World Forum for Harmonization of Vehicle Regulations

Proposal for Supplement 14 to the 02 series of amendments to UN Regulation No. 117 (Tyre rolling resistance, rolling noise and wet grip)

Submitted by the Working Party on Noise and Tyres*

Examples of separate UN Regulation No. 117 approval marks

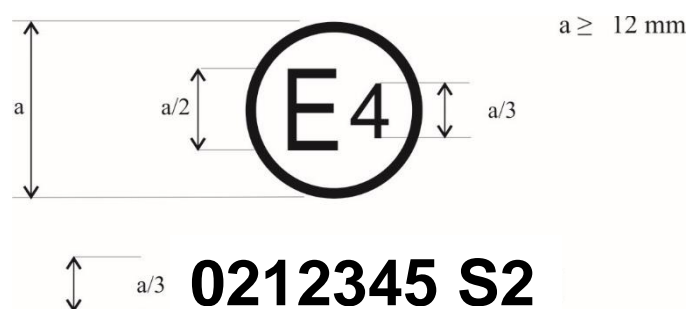
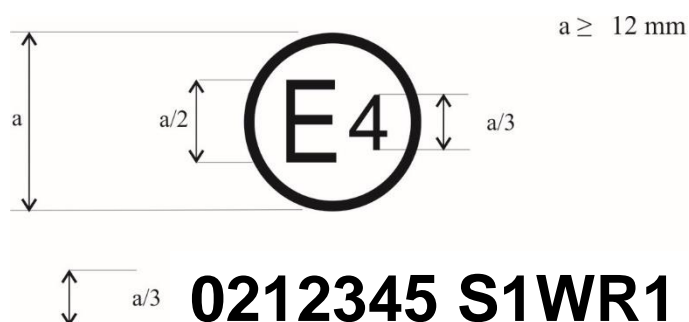
Annex 2 - Appendix 1, amend to read:

The above approval mark, affixed to a tyre shows that a tyre concerned has been approved in the Netherlands (E 4) pursuant to Regulation No. 117 (marked by "S2"), under approval number 0212345. This indicates that the approval is for rolling sound at stage 2 (S2). The first two digits of the approval number (02) indicate that the approval was granted in accordance with this Regulation which included 02 series of amendments.

The above approval mark shows that the tyre concerned has been approved in the Netherlands (E 4) pursuant to Regulation No. 117 (marked by "S1WR1") under approval number 0212345. This indicates that the approval is for rolling sound at stage 1 (S1), wet adhesion (W) and rolling resistance at stage 1 (R1). The first two digits of the approval number ("02") indicate that the approval was granted in accordance with this Regulation which included the 02 series of amendments."

Approval according to UN Regulation No. 117 coincident with approval of UN Regulations Nos. 30 or 54

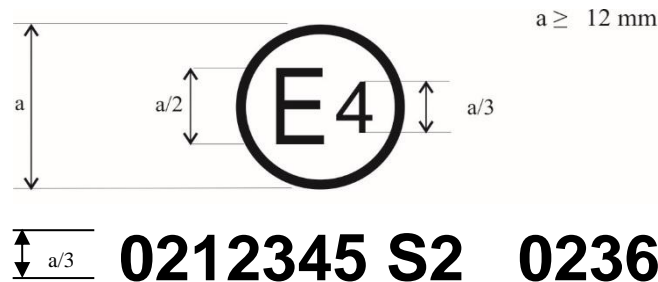
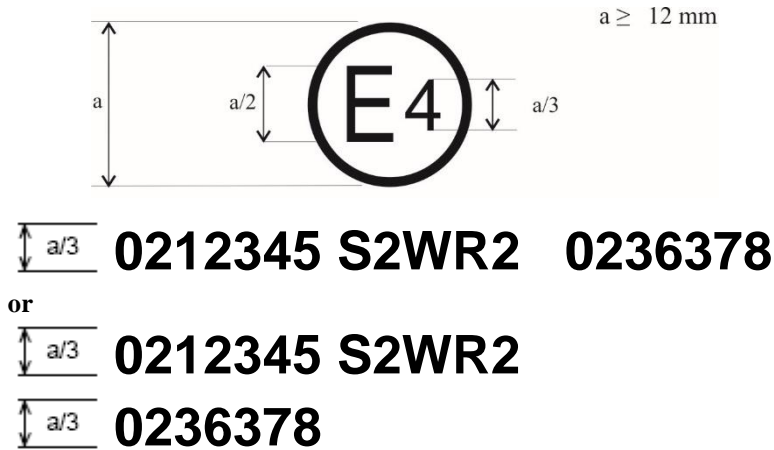
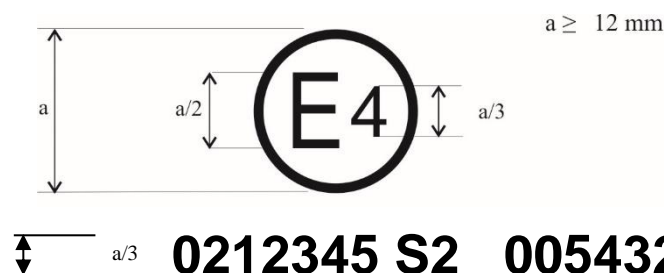
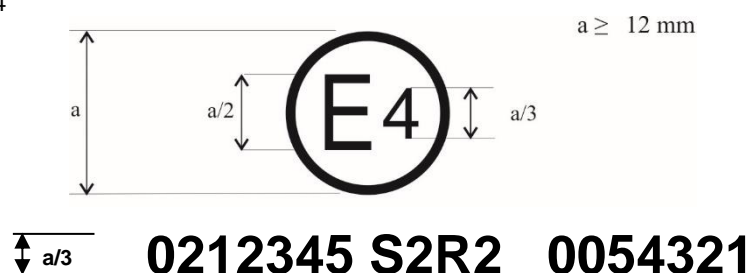
Annex 2 - Appendix 2, delete footnote 1 and amend to read:

The above approval mark shows that the tyre concerned has been approved in the Netherlands (E 4) pursuant to UN Regulation No. 117 (marked by "S2"), under approval number 0212345 and UN Regulation No. 30, under approval number 0236378. This indicates that the approval is for rolling sound at stage 2 (S2). The first two digits of the approval number ("02") in conjunction with "S2" indicate that the approval was granted in accordance with UN Regulation No. 117 which included the 02 series of amendments. The first two digits of the UN Regulation No. 30 approval number ("02") indicate that this Regulation included the 02 series of amendments.

The above approval mark shows that the tyre concerned has been approved in the Netherlands (E 4) pursuant to UN Regulation No. 117 (marked by "S2WR2"), under approval number 0212345 and UN Regulation No. 30, under approval number 0236378. This indicates that the approval is for rolling sound at stage 2 (S2), wet adhesion (W) and rolling resistance at stage 2 (R2). The first two digits of the approval number ("02") in conjunction with "S2WR2" indicate that the first approval was granted in accordance with UN Regulation No. 117 which included the 02 series of amendments. The first two digits of the UN Regulation No. 30 approval number ("02") indicate that this Regulation included the 02 series of amendments.

The above approval mark shows that the tyre concerned has been approved in the Netherlands (E 4) pursuant to UN Regulation No. 117 and the 02 series of amendments under approval number 0212345 (marked by "S2"), and UN Regulation No. 54, under approval number 0054321. This indicates that the approval is for rolling sound stage 2 (S2). The first two digits of the UN Regulation No. 117 approval number ("02") in conjunction with "S2" indicate that the first approval was granted in accordance with UN Regulation No. 117 which included the 02 series of amendments. The first two digits of the UN Regulation No. 54 approval number ("00") indicate that this Regulation was in its original form.

The above approval mark shows that the tyre concerned has been approved in the Netherlands (E 4) pursuant to UN Regulation No. 117 and the 02 series of amendments under approval number 0212345 (marked by "S2R2"), and UN Regulation No. 54, under approval number 0054321. This indicates that the approval is for rolling sound stage 2 (S2) and rolling resistance stage 2 (R2). The first two digits of the UN Regulation No. 117 approval number ("02") in conjunction with "S2R2" indicate that the first approval was granted in accordance with UN Regulation No. 117 which included the 02 series of amendments. The first two digits of the UN Regulation No. 54 approval number ("00") indicate that this Regulation was in its original form."

Combinations of markings of approvals issued in accordance with UN Regulations Nos. 117, 30 or 54

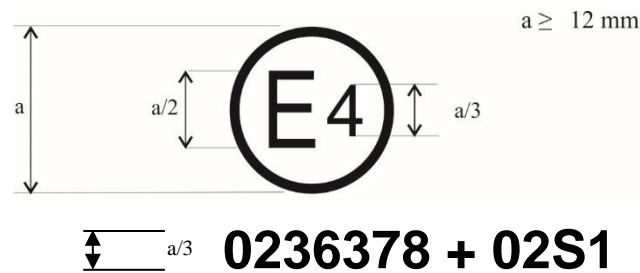
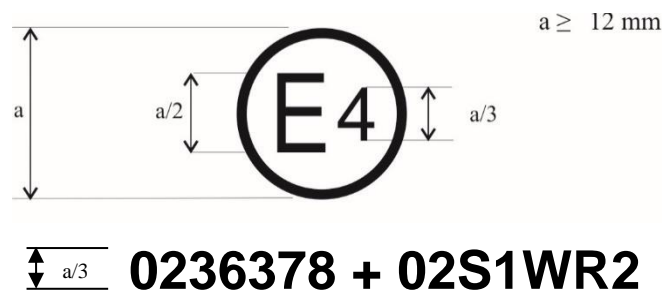
Annex 2 - Appendix 3, amend to read:

The above approval mark shows that the tyre concerned has been approved in the Netherlands (E 4) pursuant to UN Regulation No. 30 according to its 02 series of amendments (indicated by the first two digits of the approval number, "02") under approval number 0236378. It is also marked by "+ 02S1" which indicates that the tyre was also approved pursuant to UN Regulation No. 117 (02 series of amendments) for rolling sound at stage 1.

The above approval mark shows that the tyre concerned has been approved in the Netherlands (E 4) pursuant to Regulation No. 30 according to its 02 series of amendments (indicated by the first two digits of the approval number, "02") under approval number 0236378. It is also marked by "+ 02S1WR2" which indicates that the tyre was also approved pursuant to UN Regulation No. 117 (02 series of amendments) for S1 (rolling sound at stage 1), W (wet adhesion) and R2 (rolling resistance at stage 2)."

Extensions to combine approvals issued in accordance with Regulation No. 117

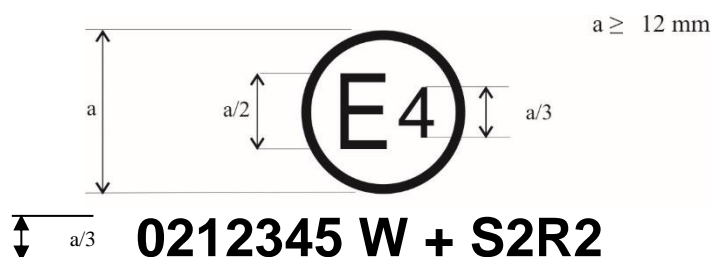
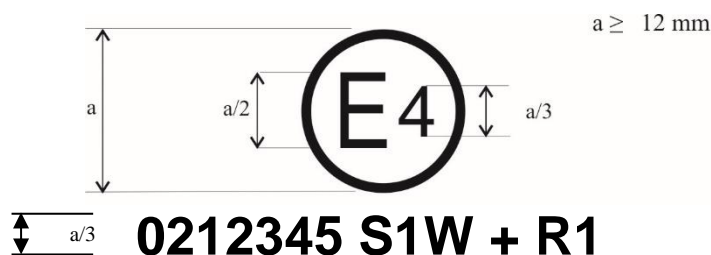
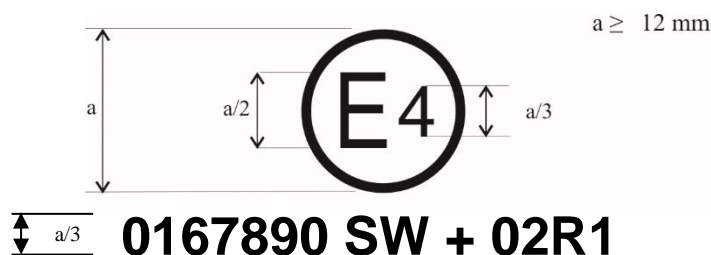
Annex 2 - Appendix 4, delete footnote 1 amend to read:

The above approval mark shows that the tyre concerned has been initially approved in the Netherlands (E 4) pursuant to UN Regulation No. 117 according to its 02 series of amendments (indicated by the first two digits of the approval number, "02") under approval number 0212345 (marked by "W"). This indicates that the approval is for W (wet adhesion). The "S2R2" preceded by "+" indicates that its approval has been extended under UN Regulation No. 117 to rolling sound at stage 2 and rolling resistance at stage 2 based on separate certificate(s).

The above approval mark shows that the tyre concerned has been initially approved in the Netherlands (E 4) pursuant to UN Regulation No. 117 according to its 02 series of amendments (indicated by the first two digits of the approval number, "02") under approval number 0212345 (marked by "S1W"). This indicates that the approval is for S1 (rolling sound at stage 1) and W (wet adhesion). The "R1" preceded by "+" indicates that its approval has been extended under Regulation No. 117 to rolling resistance at stage 1 based on separate certificate(s).

The above approval mark shows that the tyre concerned has been initially approved in the Netherlands (E 4) pursuant to UN Regulation No. 117 according to its 01 series of amendments (indicated by the first two digits of the approval number, "01") under approval

number 0167890 (marked by "SW"). This indicates that the approval is for S (rolling sound at stage 1) and W (wet adhesion). The "02R1" preceded by "+" indicates that its approval has been extended under UN Regulation No. 117 according to its 02 series of amendments to rolling resistance at stage 1 based on separate certificate(s)."
